Facilities & Operations Committee Meeting August 2026

RE: North Penn High School BP-1
Change Order Request #37
Admin F-17 Corridor Temp Doors and Wall Framing

RE: North Penn High School BP-2
Change Order Request #19 Utility Conflicts
Mar. 12 thru Apr. 06

**Wescott Electric Company
Change Order Proposal
North Penn High School**

F-17

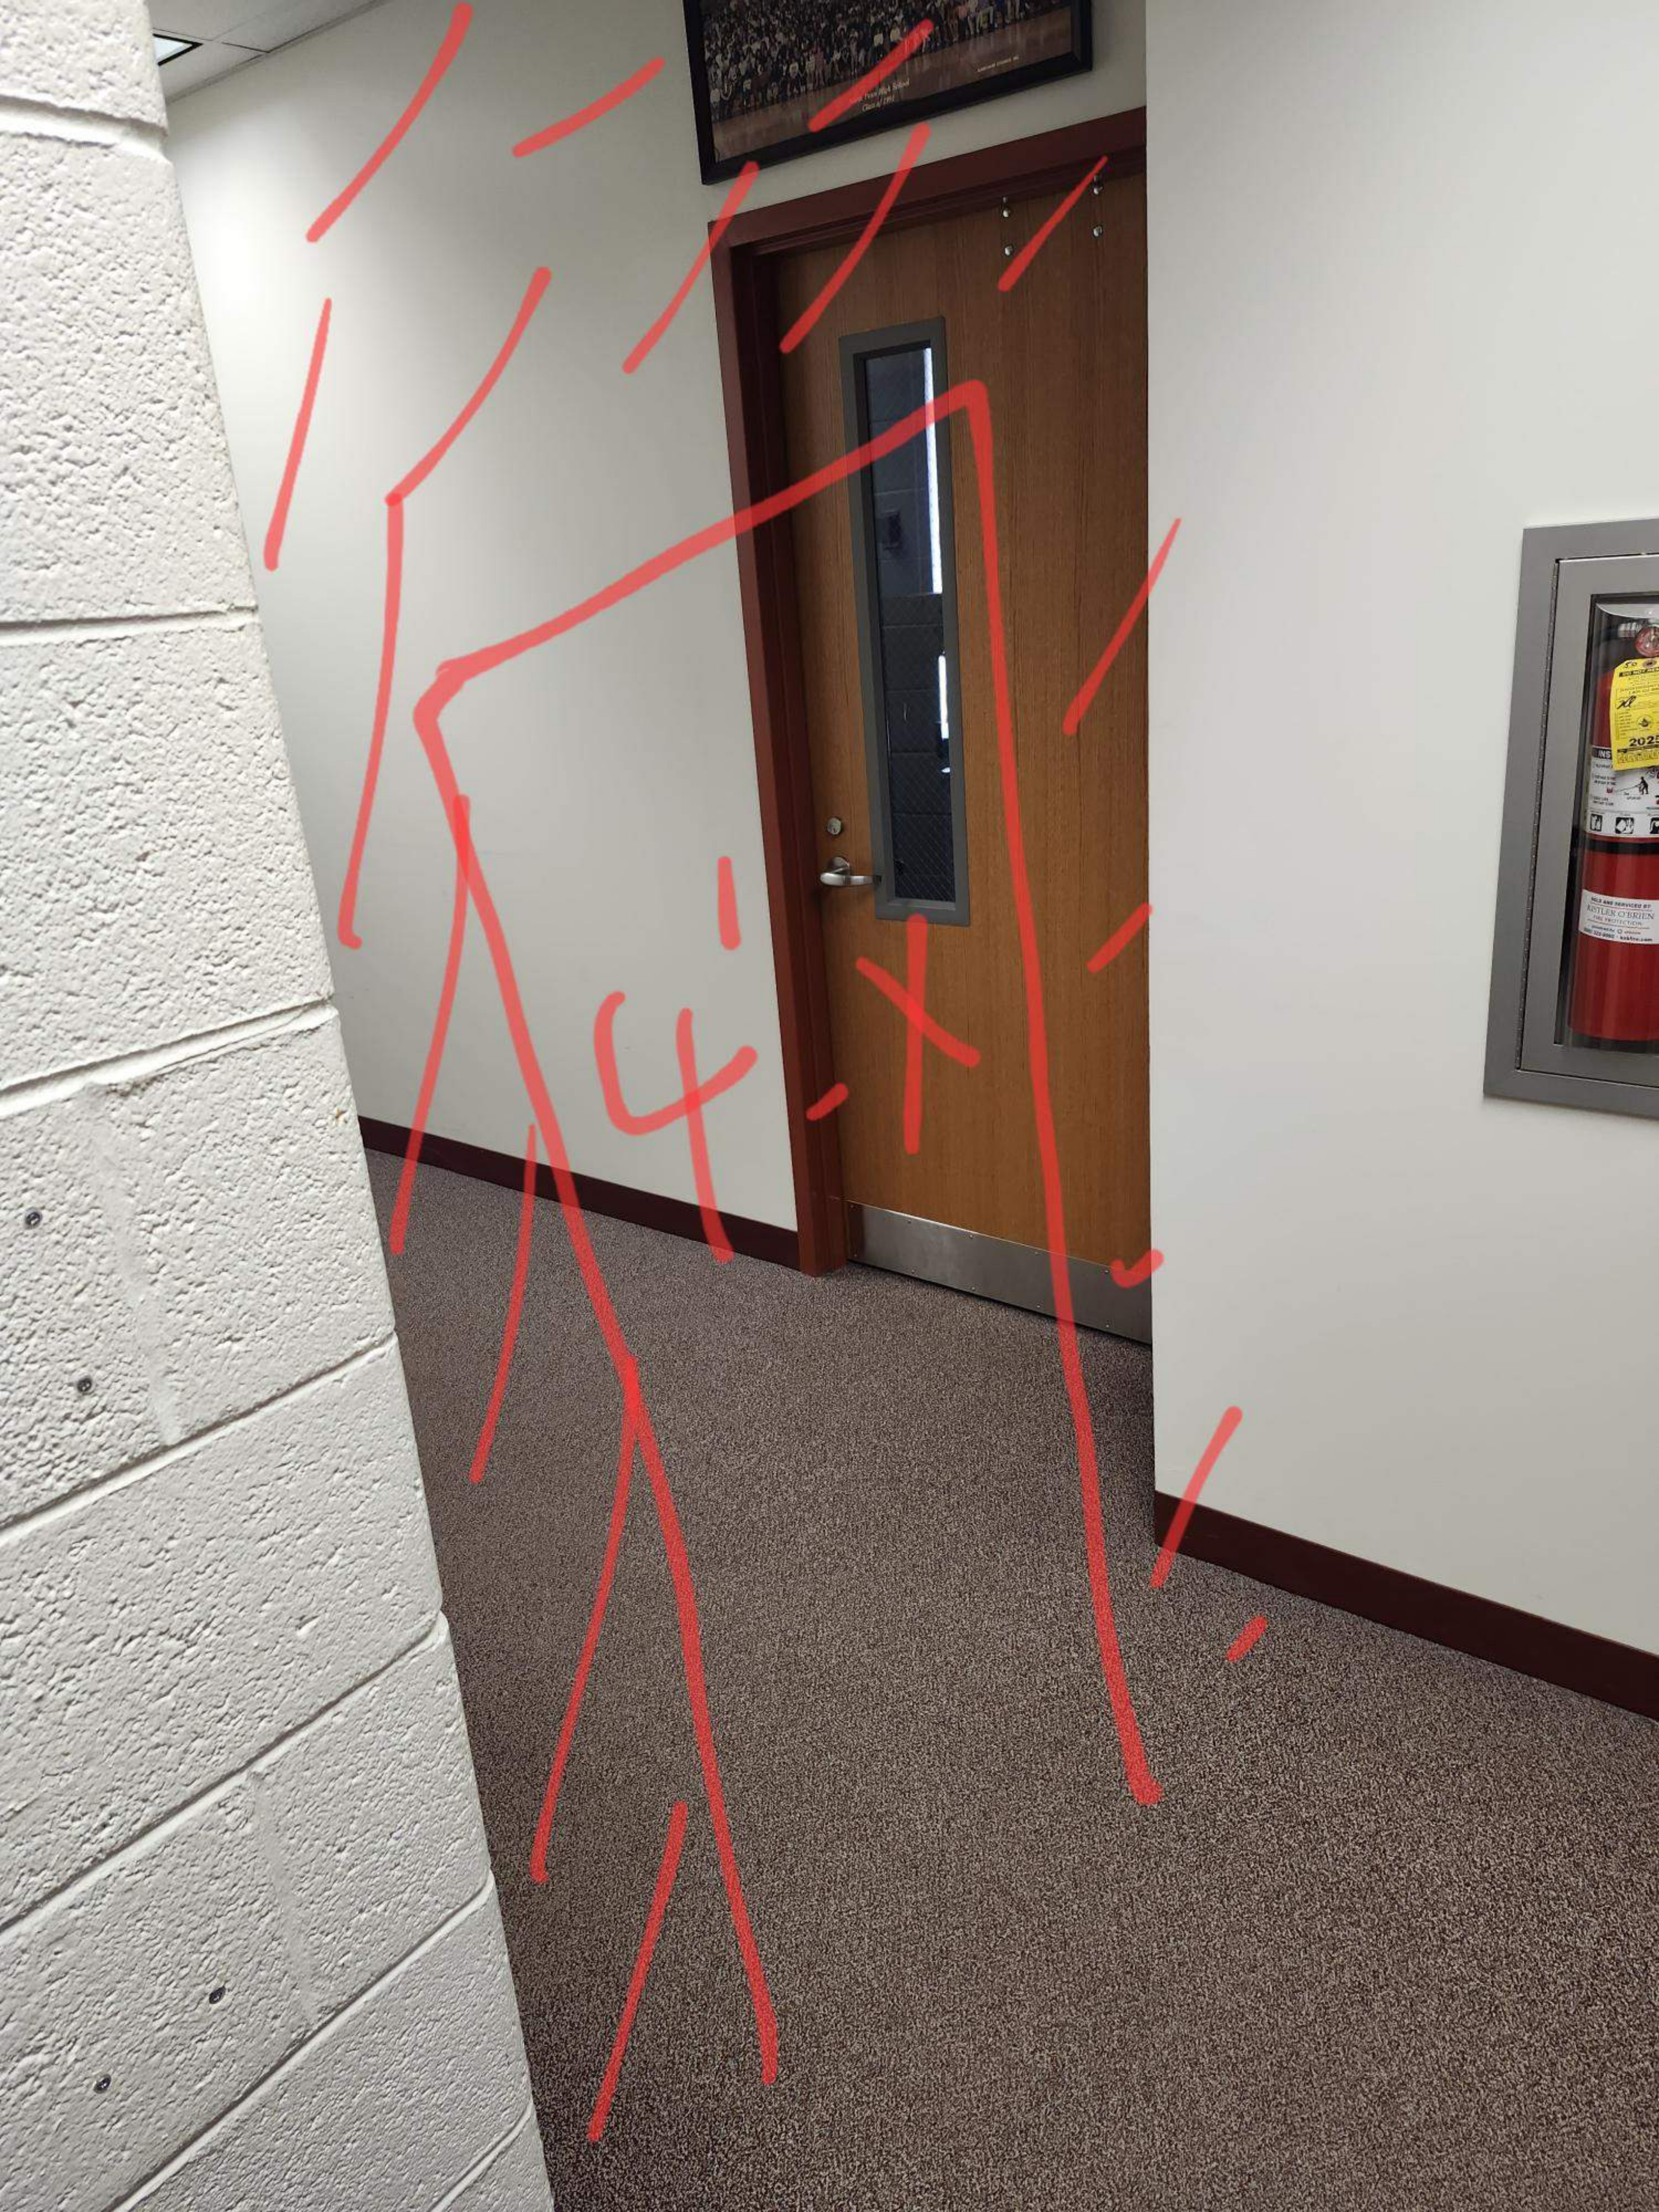
Per the owner's request, please find attached and below the additional cost for materials and labor to provide two temporary doors, frames, and wall framing up to the deck in the F-17 admin hallway. Door frames, doors, and hardware are being repurposed from areas being demoed. Floor base is being provided to match other areas including the library temp classrooms at no additional cost.

Add two 3-5/8" MS walls to deck, level 4 finish in admin office space.

1 FIRST FLOOR PLAN - POWER - AREA B
BP2-E301.B SCALE: 1/8" = 1'-0"

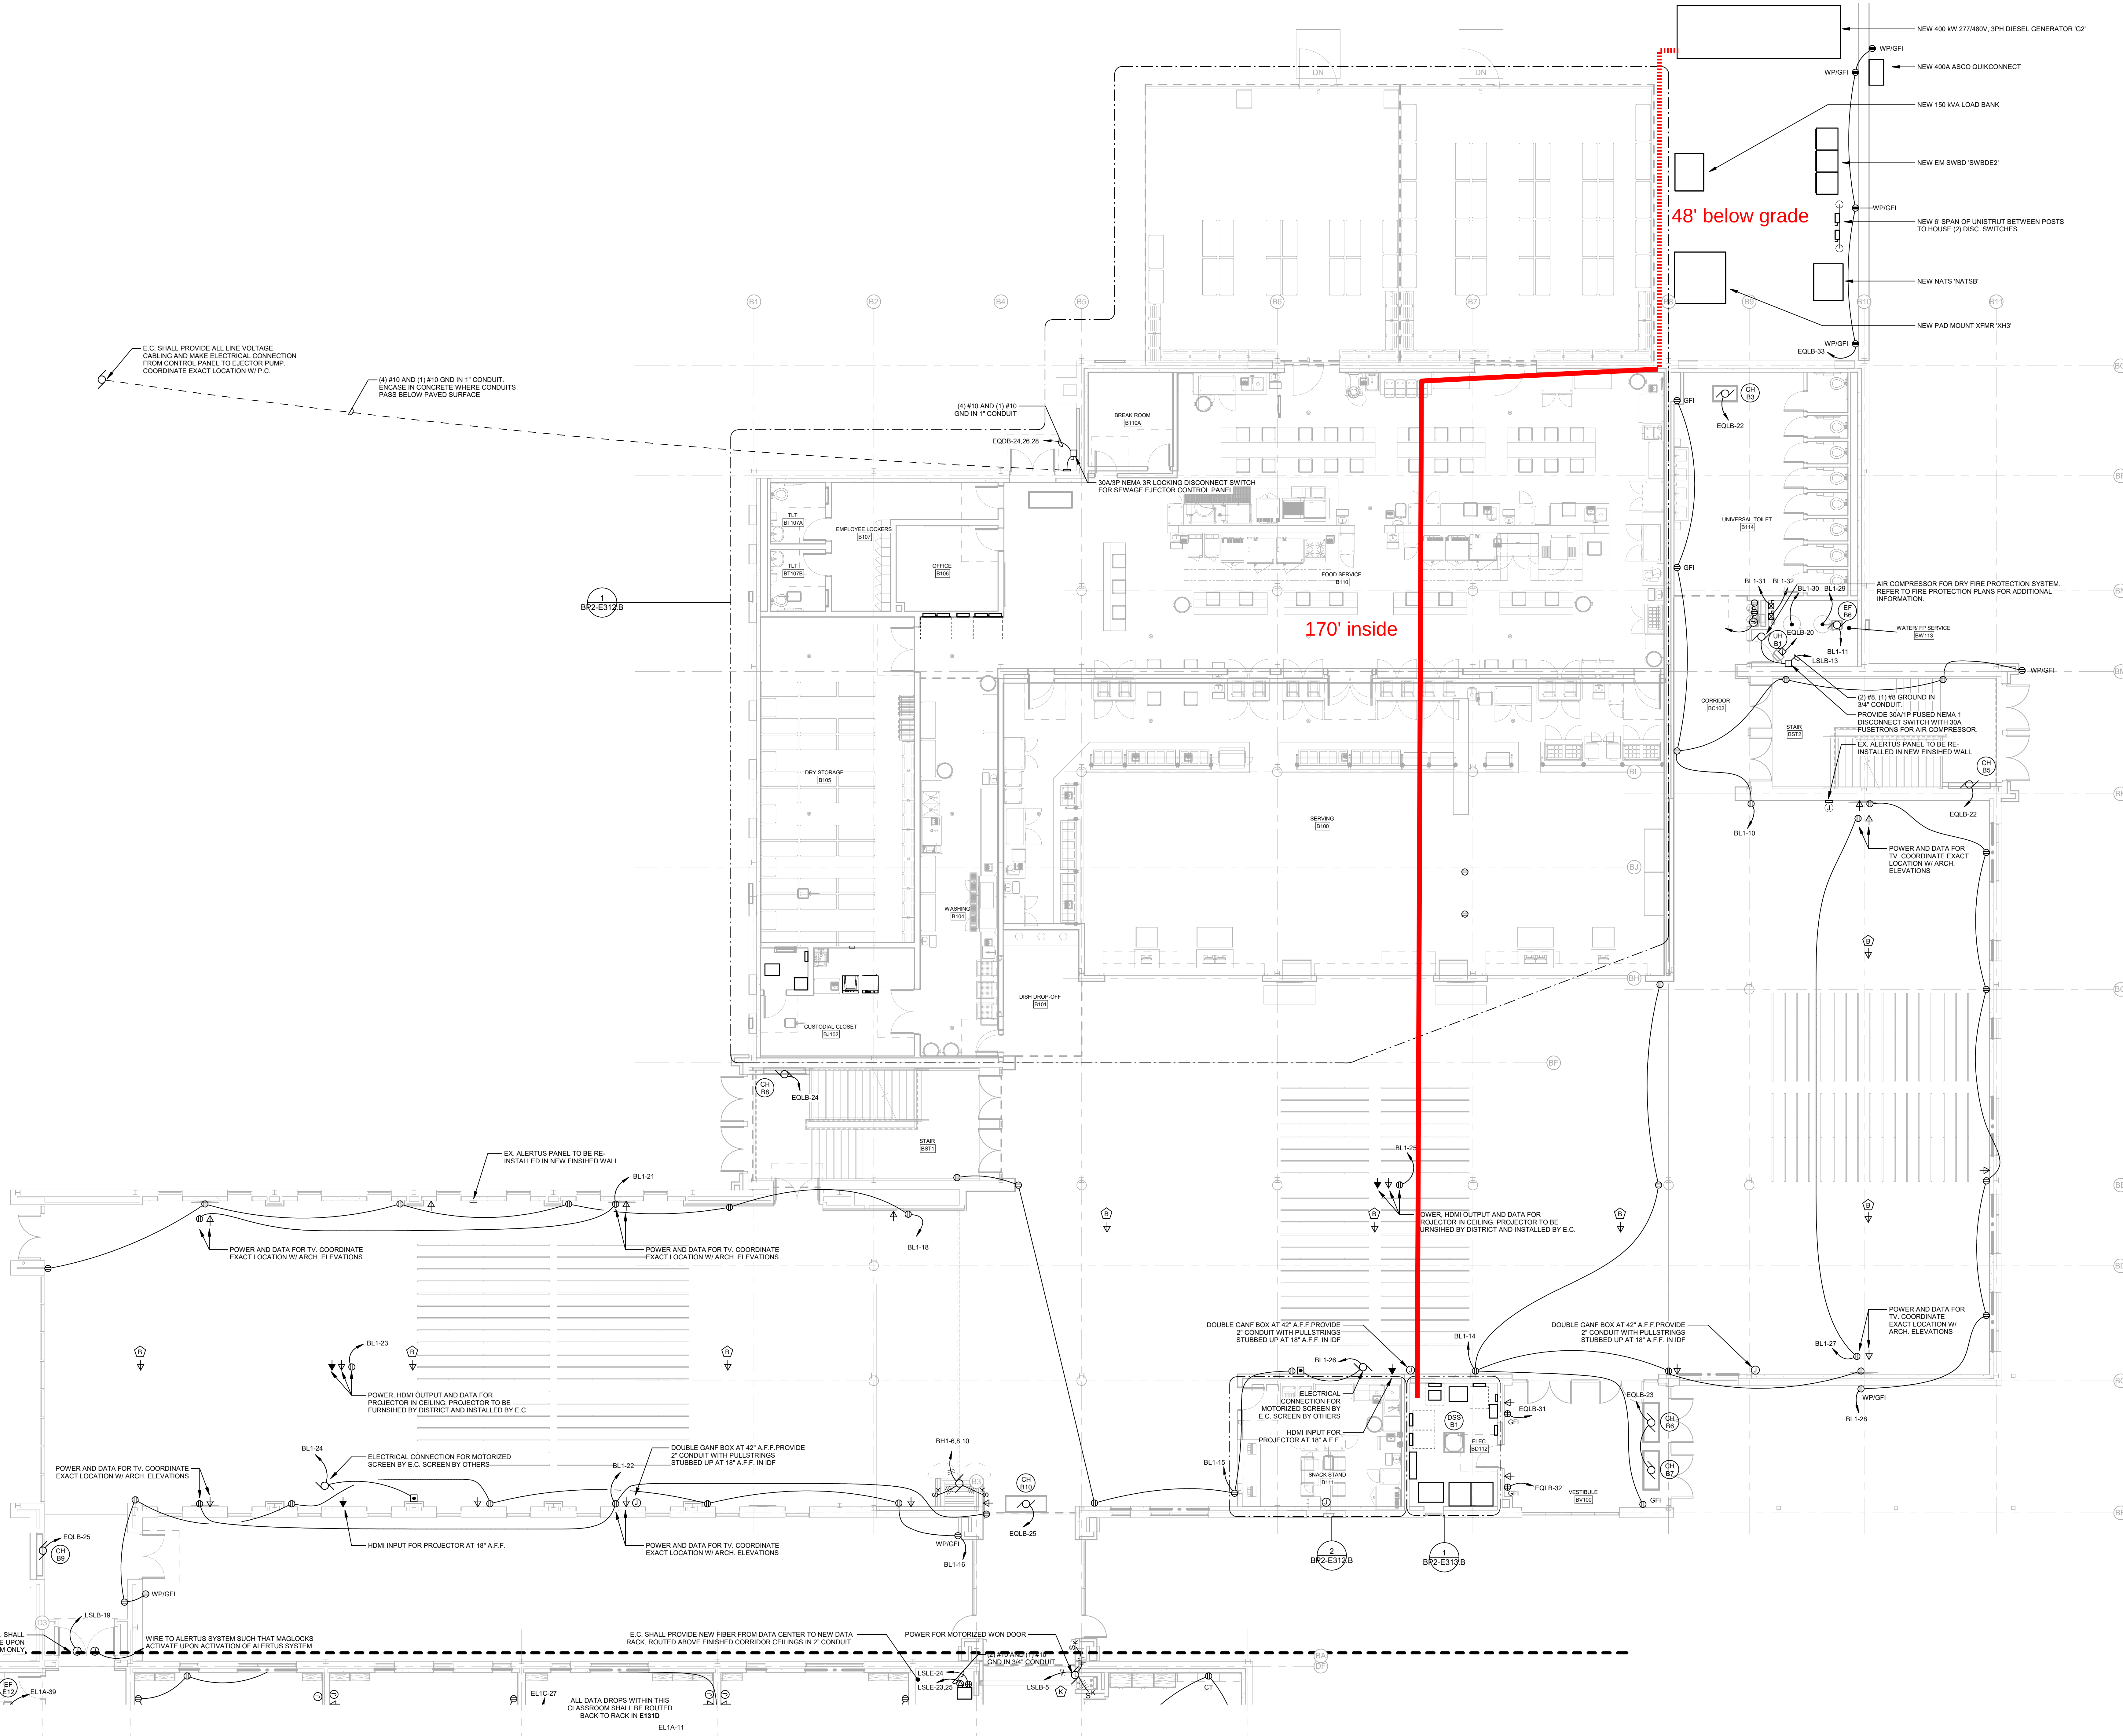
Drawing E502 indicates a 100a load center to be integral to the 600 kw generator labeled 'G1'. The 500kw generator labeled 'G2' does not have a note indicating an integral load center. Spec page 263213-15 section 6 sub section 5 for generators calls out a load center to be integral to the generators. Is generator G2 to be supplied with an integral lead center? If so please provide panel designation, wire size, and conduit size.

1. RFI Number 003	Responsible Contractor Wescott Electric	Date 09/30/2025
Description: Drawing E502 indicates a 100a load center to be integral to the 600 kw generator labeled 'G1'. The 500kw generator labeled 'G2' does not have a note indicating an integral load center. Spec page 263213-15 section 6 sub section 5 for generators calls out a load center to be integral to the generators. Is generator G2 to be supplied with an integral lead center? If so please provide panel designation, wire size, and conduit size.		
References: 263213		
Requested By: Darrell Putnam		Date 09-29-25

Generator 'G2' shall be provided with a 100A 120/208V integral load center, per specification to feed all generator accessories as indicated in note at generator 'G1' on sheet BP2-E502. Load center shall be fed out of new 100A/3P breaker in provisional spaces 'EQLB-36,38,40' and wired with (4) 3/0 and (1) #4 gnd in 2-1/2" conduit.

2. A/E Response, or Comments (if applicable): Generator 'G2' shall be provided with a 100A 120/208V integral load center, per specification to feed all generator accessories as indicated in note at generator 'G1' on sheet BP2-E502. Load center shall be fed out of new 100A/3P breaker in provisional spaces 'EQLB-36,38,40' and wired with (4) 3/0 and (1) #4 gnd in 2-1/2" conduit.		
A/E (Signature):	Date	Contract Document Impact ☐ Yes ☐ No Revisions Attached { ☐ Yes ☐ No
